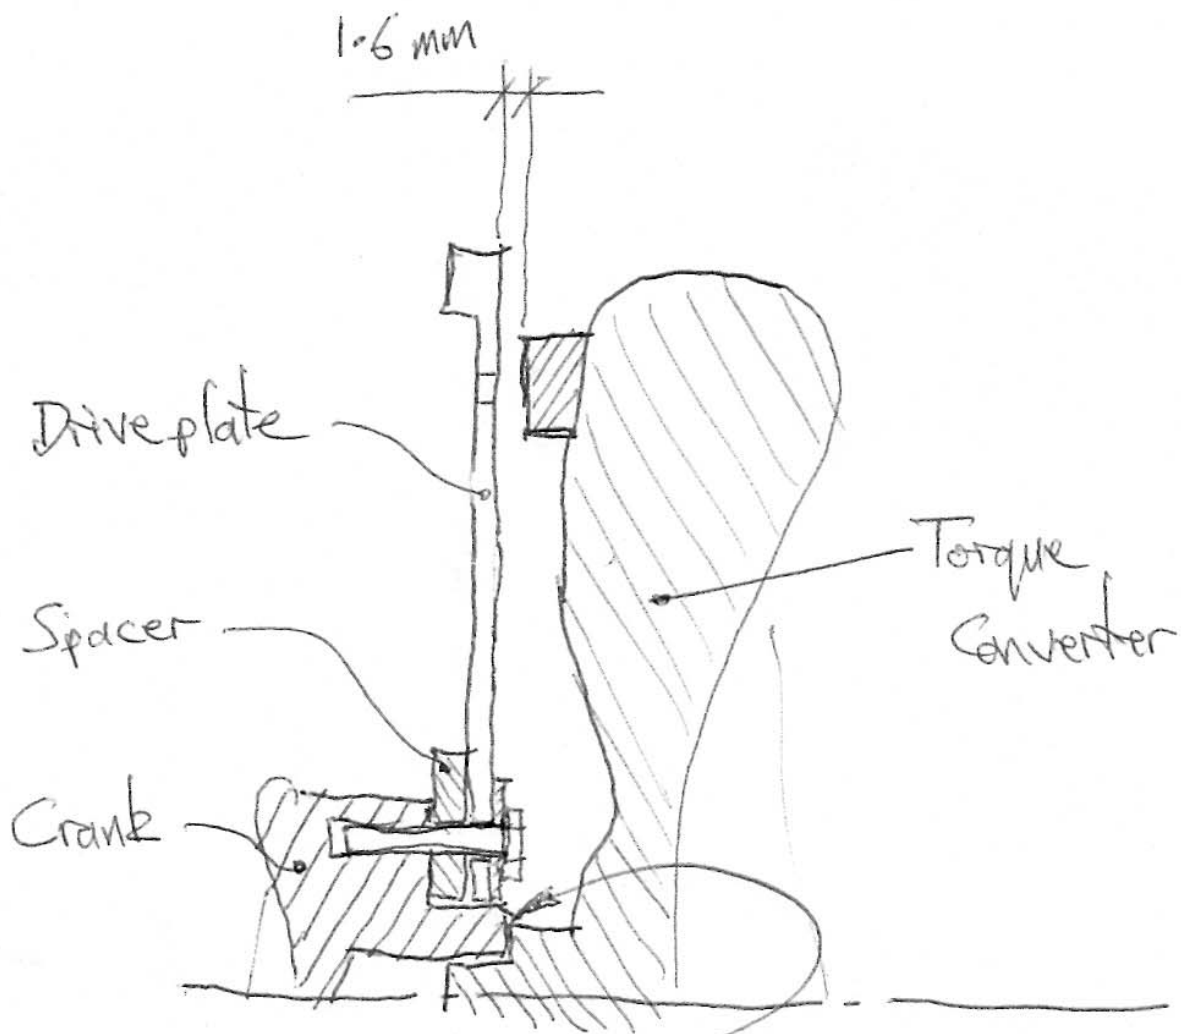
Shoulder on spigot hard against crank. Approx 2mm gap at boss.

Witness marks on boss and drive plate show it was originally bolted tight.

Is a $\pm 2\text{mm}$ ok acceptable or should washers be used between boss and drive plate?
